January 27, 2022

RE: Docket Number EERE-2017-BT-STD-0014/RIN 1904-AD98: Energy Conservation Standards for Residential Clothes Washers

Figure 1: Rated IMEF (left) and estimated EER (right) versus capacity for top-loading standard washers.

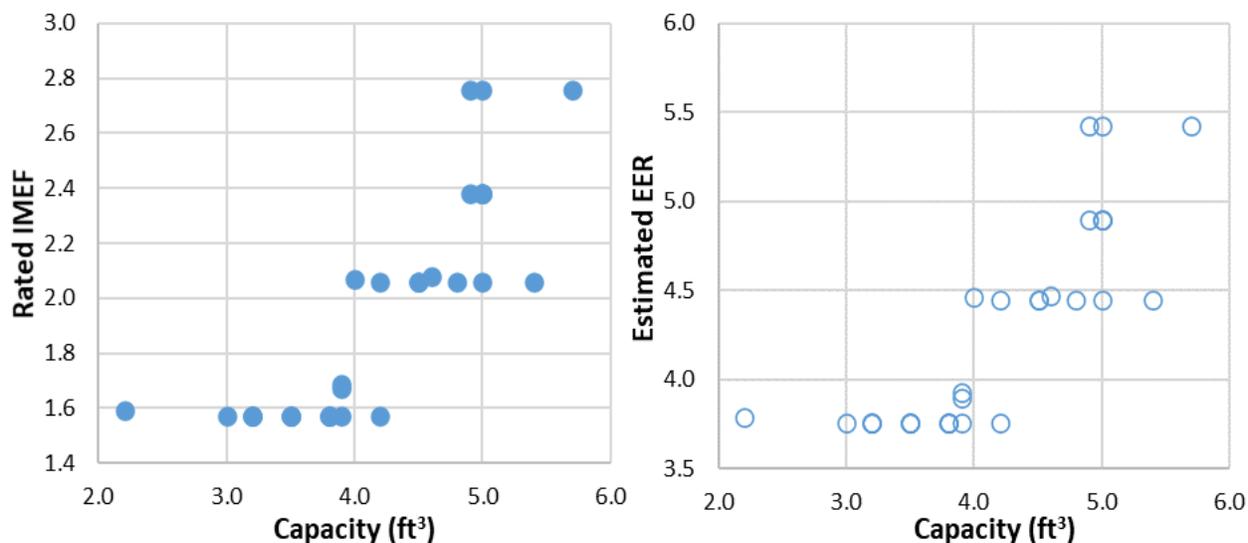
We encourage DOE to investigate the correlation between washer capacity and measured efficiency. We support the proposed change in the September 2021 test procedure NOPR to make the water and energy usage metrics based on lbs. of clothes washed rather than capacity, which will help mitigate the current bias towards large-capacity washers. However, DOE’s preliminary testing presented in the PTSD suggests that for at least top-loading standard washers, large-capacity washers still achieve higher efficiency ratings. While the model-predicted and tested EERs are not tabulated in the PTSD as a function of capacity, Figure 1 plots rated IMEF (left) and linear-fit estimated EERs³ (right) versus capacity for the 30 top-loading washers in DOE’s test sample.⁴ While the correlation between capacity and efficiency is slightly less pronounced for EER than for IMEF, it persists based on this preliminary analysis. We thus encourage DOE to investigate whether this results from: 1) larger machines being inherently more efficient, 2) larger machines employing additional technology options that improve efficiency, or 3) some remaining inherent bias towards larger capacity machines. To the extent that larger machines can achieve higher EER and/or WER ratings, DOE should consider requiring higher efficiency levels for larger capacity washers. For example, DOE could consider standards that are a function of capacity.
